**Application for Variation of an Environmental Permit**

Project Title  
**First Stage of Desalination Plant at Tseung Kwan O - Investigation, Design and Construction**

Figure Title  
**Revised Figure 1 - Project Location Plan**

First Stage of Desalination Plant at Tseung Kwan O  
– Investigation, Design, Construction

Figure 1.1 Proposed Alignment of TKO Fresh Water Mains

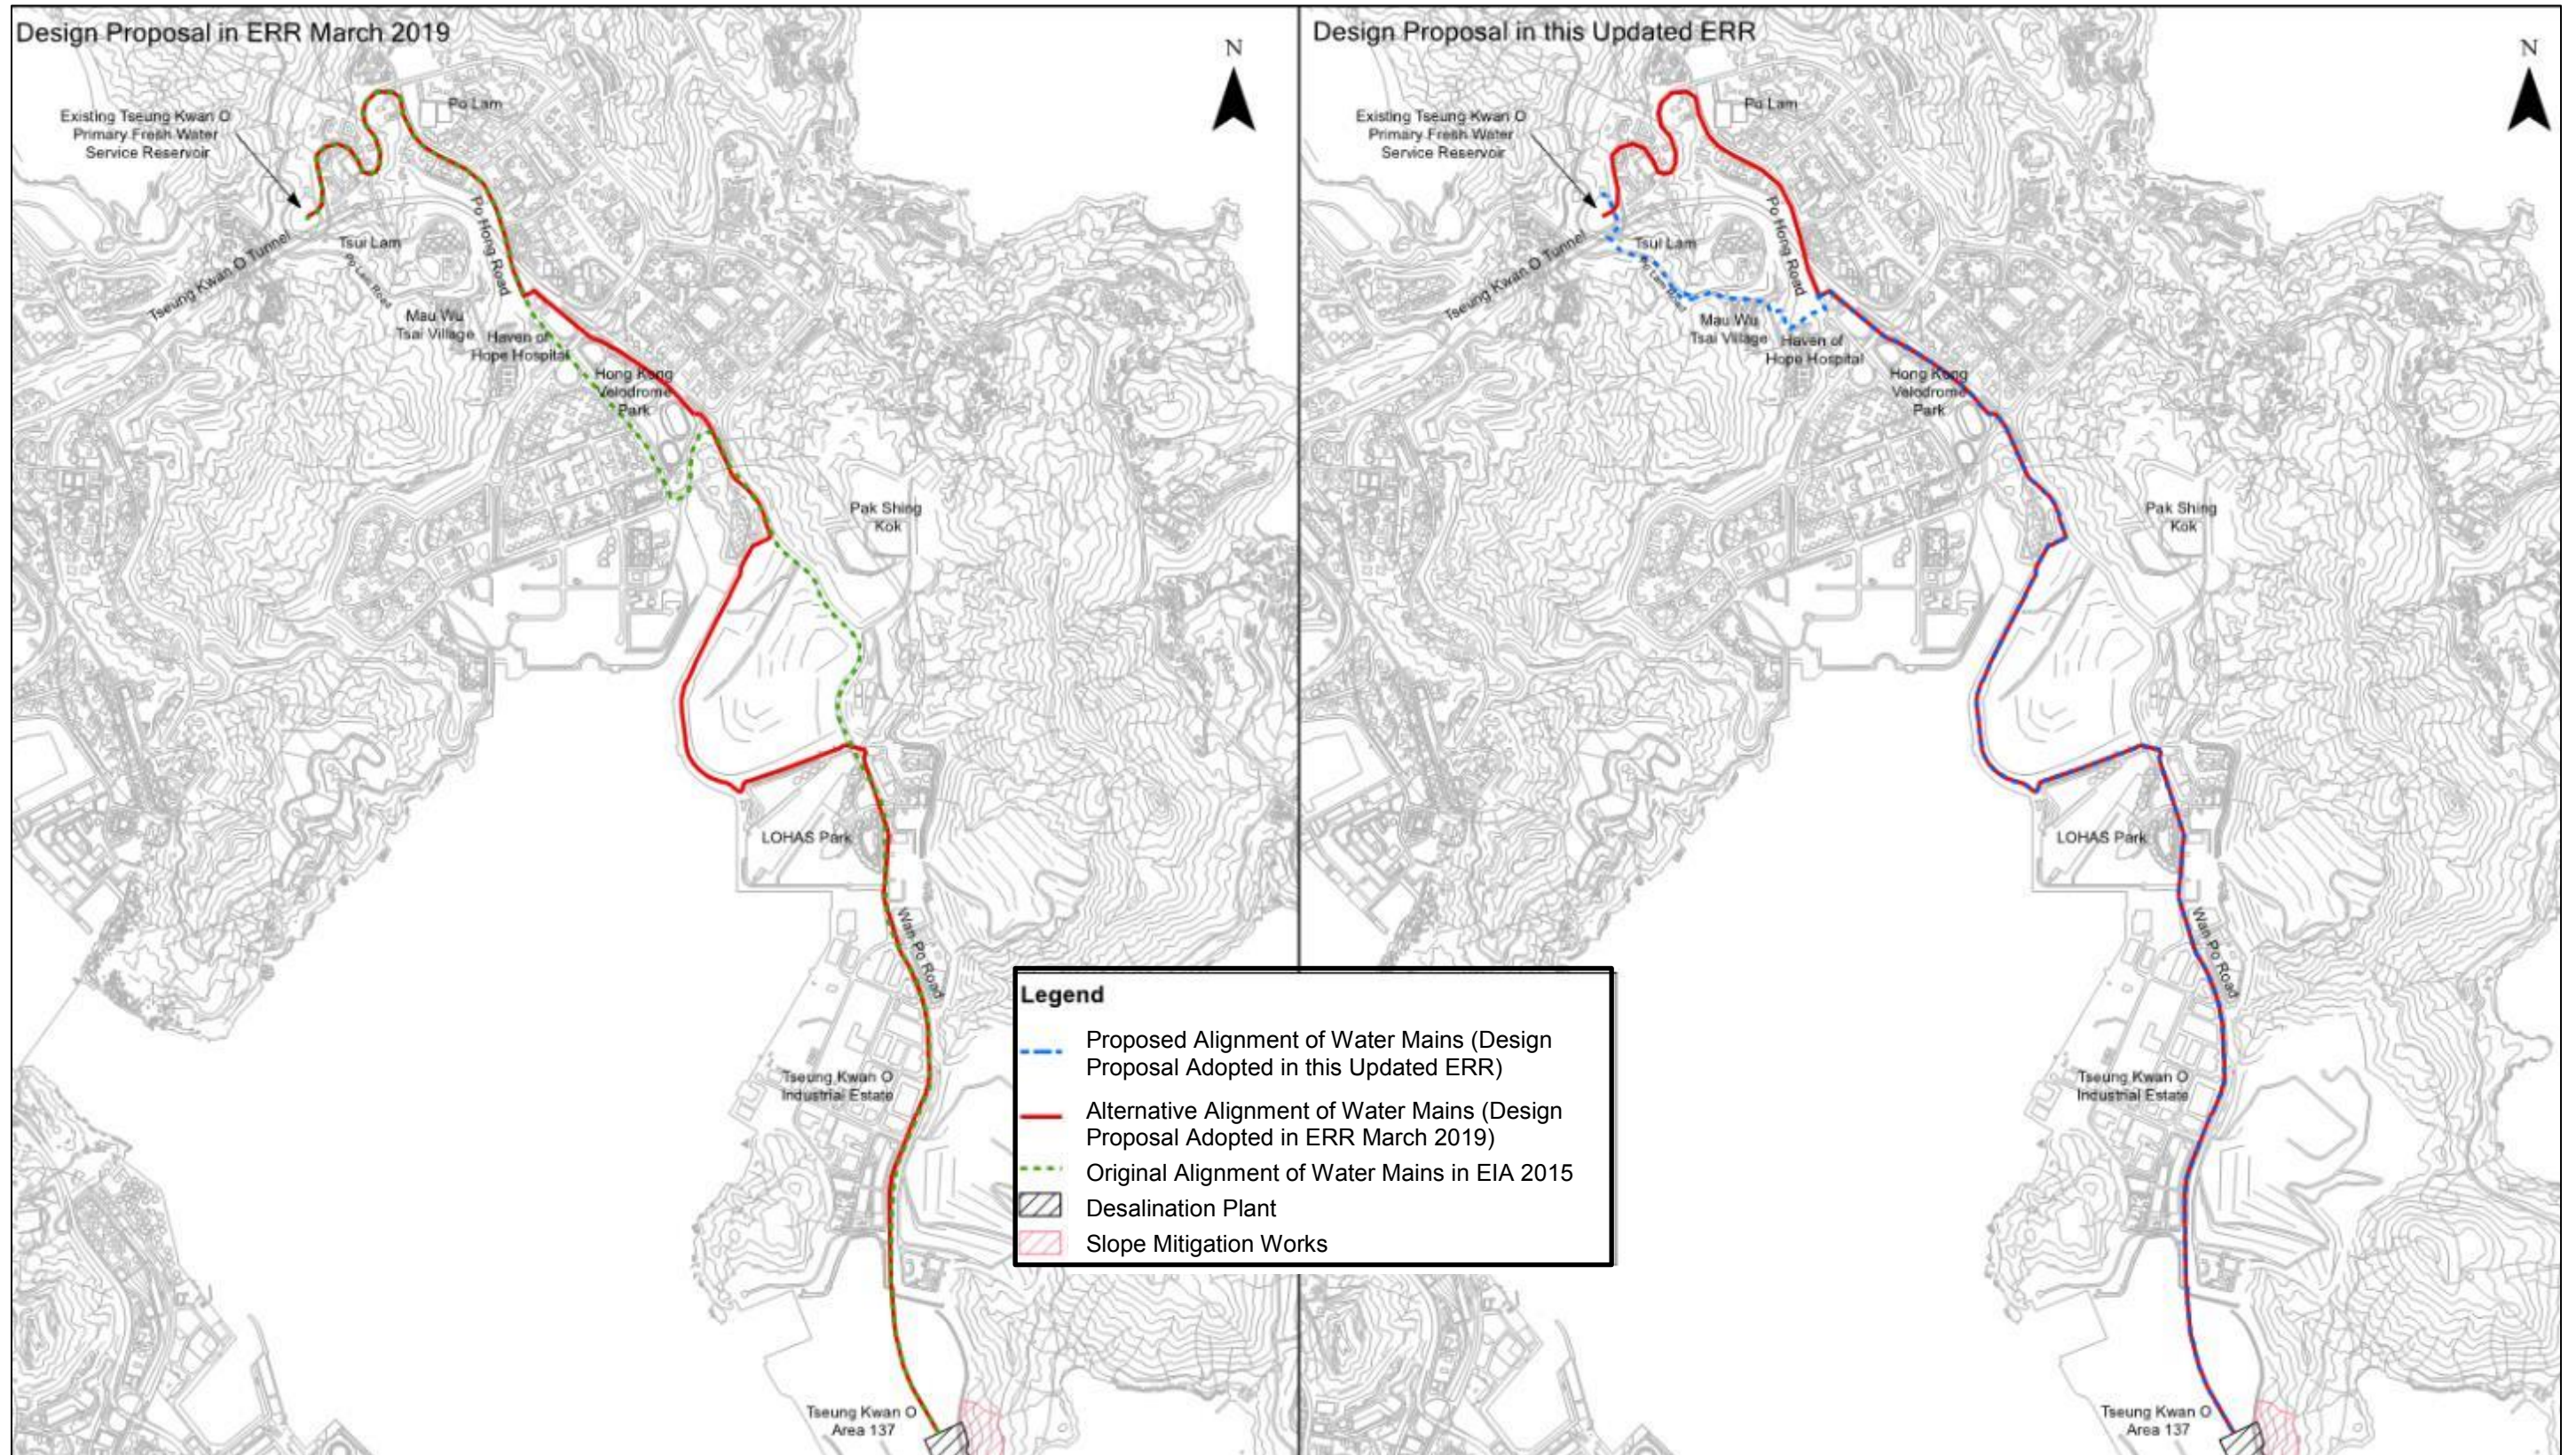
- 1.1.4 Change of the design and alignment of the fresh water mains was proposed in early 2019 under the detailed design works to resolve engineering constraints. An environmental review was carried out in early 2019 to assess the environmental impacts arising from the design change. The results of the environmental review are presented in “*Agreement No. CE 8/2015 (WS) First Stage of Desalination Plant at TKO – Investigation, Design and Construction, Environmental Review Report for Fresh Water Mains*” issued to the Environmental Protection Department (EPD) in March 2019 (hereafter also referred to as “ERR March 2019”). The Design Proposal adopted in the ERR March 2019 is also presented in **Figure 1.1**.

- 1.1.5 Recently, the need of further changing the alignment and design of the fresh water mains in the northern section close to the existing TKOFWPSR in Tsui Lam has been identified to resolve traffic constraints. This further change was not considered in the ERR March 2019.

- 1.2.1 The purpose of this Updated Environmental Review Report (ERR) is to review the potential environmental impacts arising from the latest change of the alignment and design of the fresh water mains in Tsui Lam and demonstrate that this change will not constitute material change to the environmental impact of the Project with mitigation measures in place and the Project complies with the requirements described in the Technical Memorandum on EIA Process (EIAO-TM). The proposed alignment adopted in this Updated ERR is presented in **Figure 1.1** for comparison with the alignment adopted in the ERR March 2019.

Figure 2.1 Design Proposal of TKO Fresh Water Mains in Tsui Lam Area

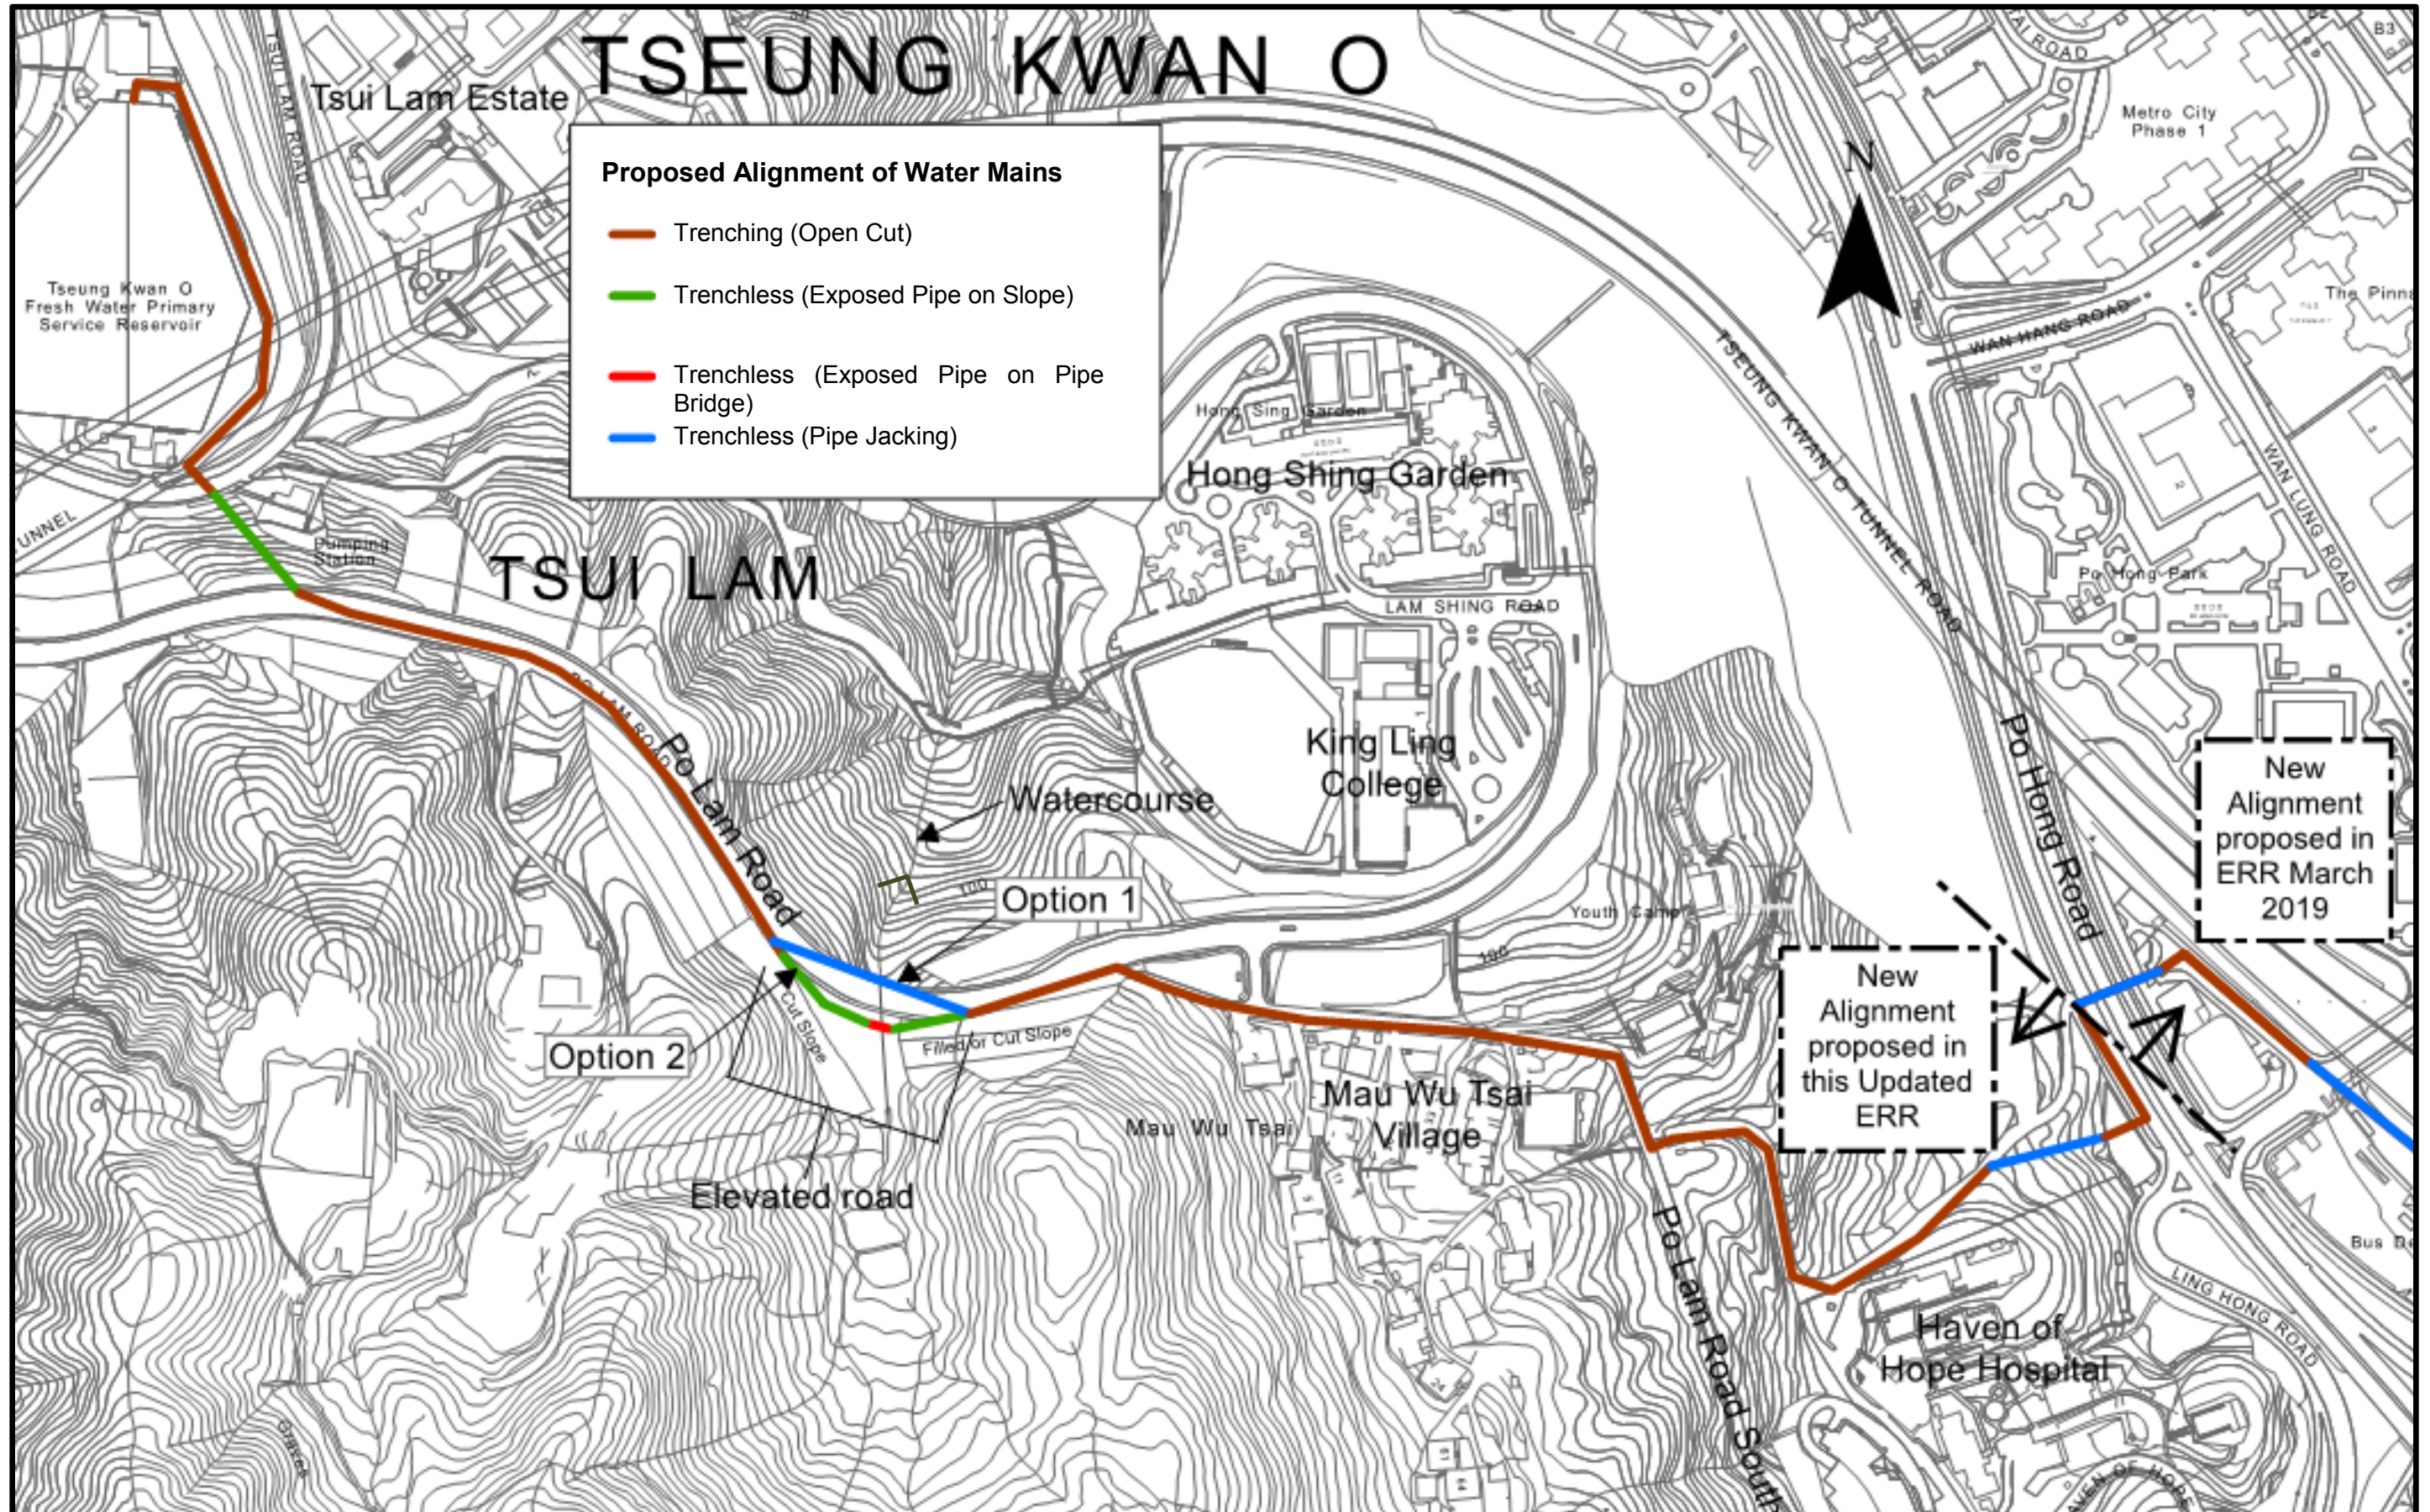
- 2.4.2 The proposed realignment in the north, namely Section C, is shown in **Figure 2.1**. This alignment would run across three areas of plantation. The western one is located on a slope south of TKOFWPSR, while the eastern one located near Po Hong Road. The third one is in the middle near the elevated section of Po Lam Road with a small watercourse running underneath the road from the south. Laying exposed pipe will be used in the western plantation patch. This method can avoid tree felling and major vegetation clearance and therefore is able to prevent habitat loss. Pipe jacking is proposed for the middle plantation patch (under Option 1) as well as on the eastern plantation patch near Po Hong Road. The whole water main will be installed underground by jacking and therefore can completely avoid vegetation clearance and surface disturbance.

- 2.4.3 The length of the pipe jacking section at Po Lam Road (Option 1) as shown in **Figure 2.1** is tentative but in any case, all surface works areas (jacking pits) would be located within existing roads only. Section plan which shows the typical work arrangement under Option 1 is provided in **Appendix 2A**.

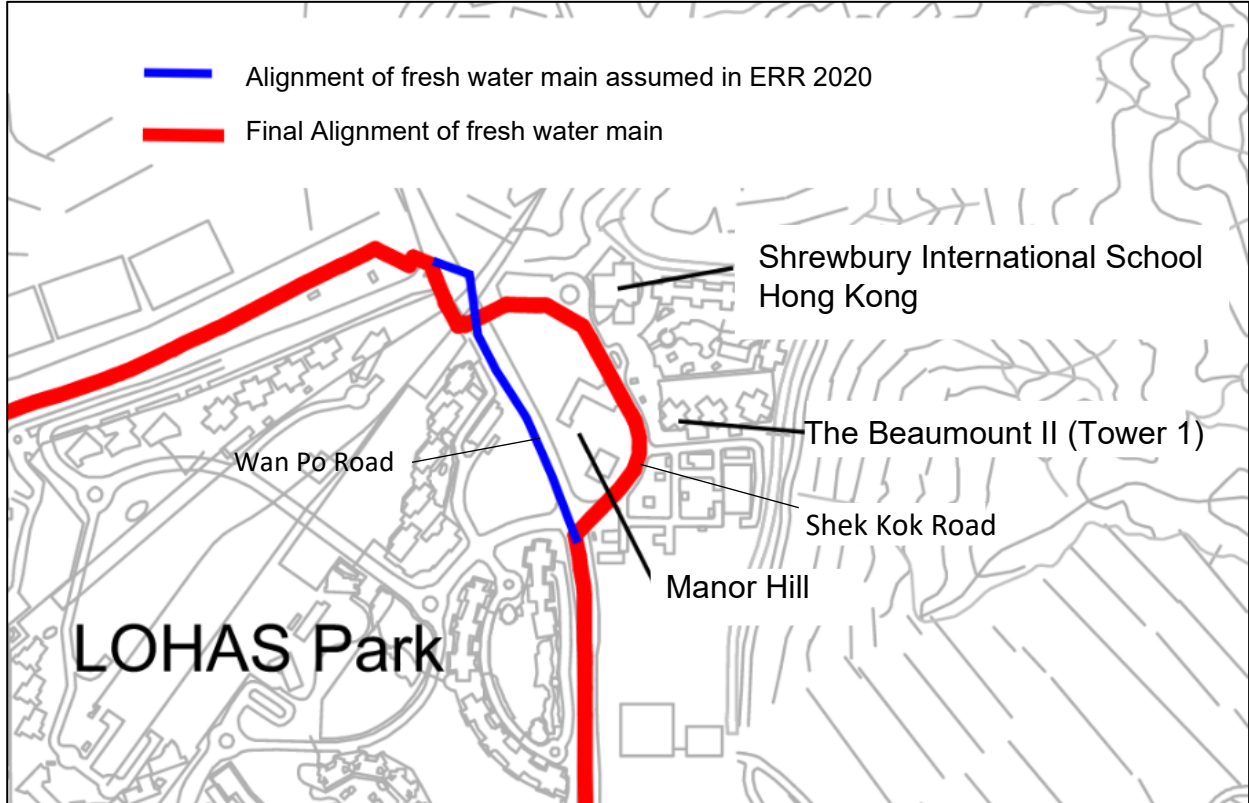
The final alignment of the fresh water main runs through Shek Kok Road, which was not considered in the ERR 2020 as illustrated in the figure below.

**Annex 2 – Deviation of Fresh Water Main Alignment No. 2**

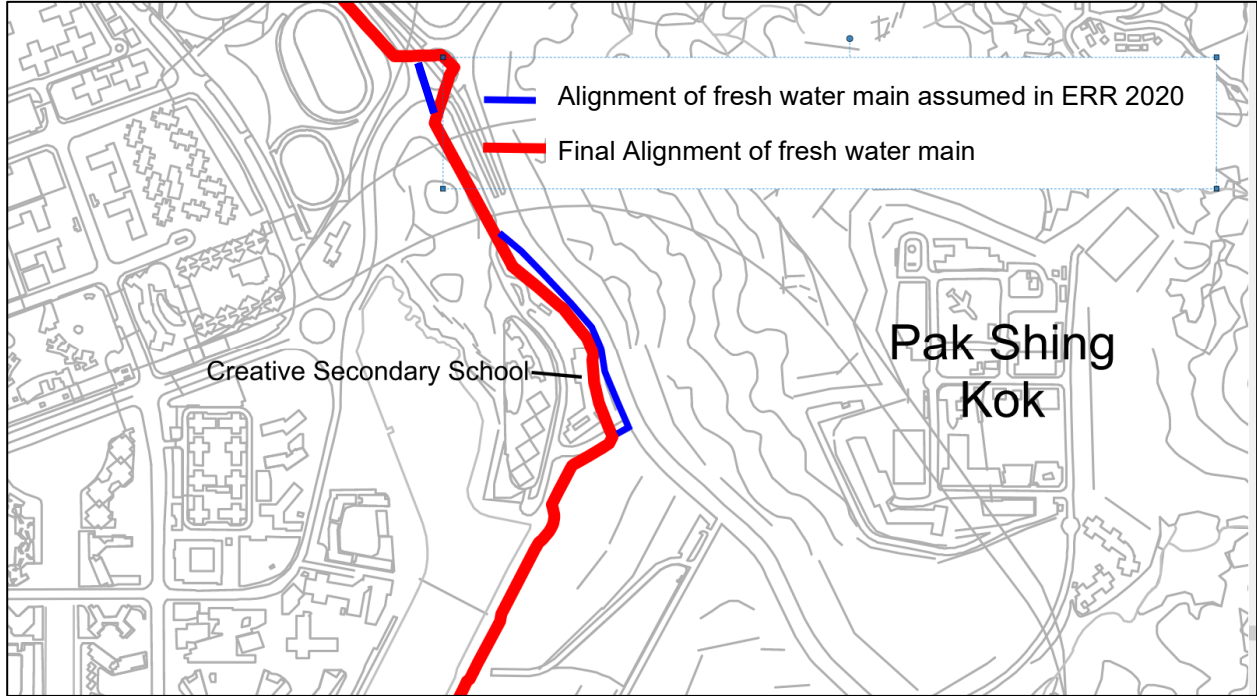
The final alignment of the fresh water main runs closer to the Creative Secondary School, which was not considered in the ERR 2020 as illustrated in the figure below.

### Annex 3 – Deviation of Fresh Water Main Alignment No. 3

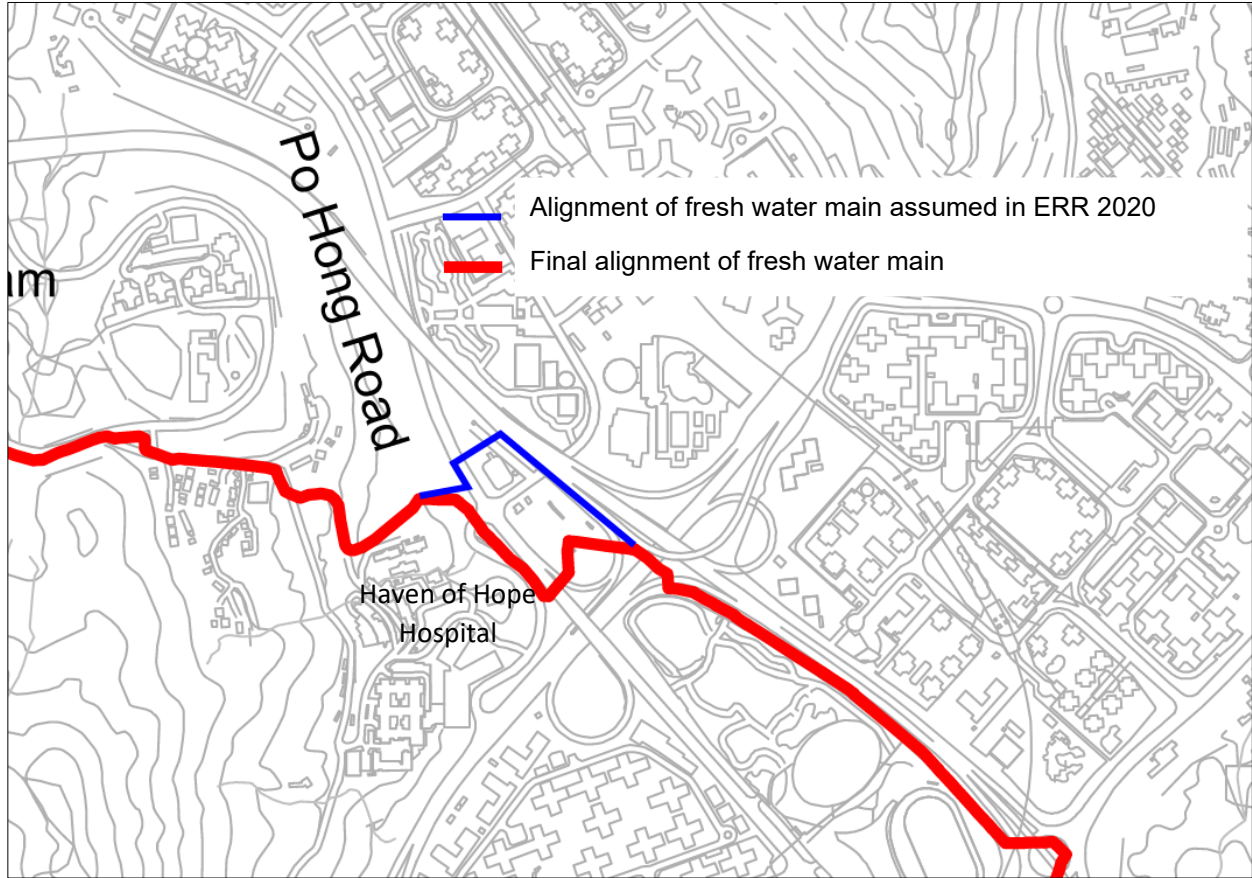
The final alignment of the fresh water main runs closer to the Haven of Hope Hospital, which was not considered in the ERR 2020 as illustrated in the figure below.
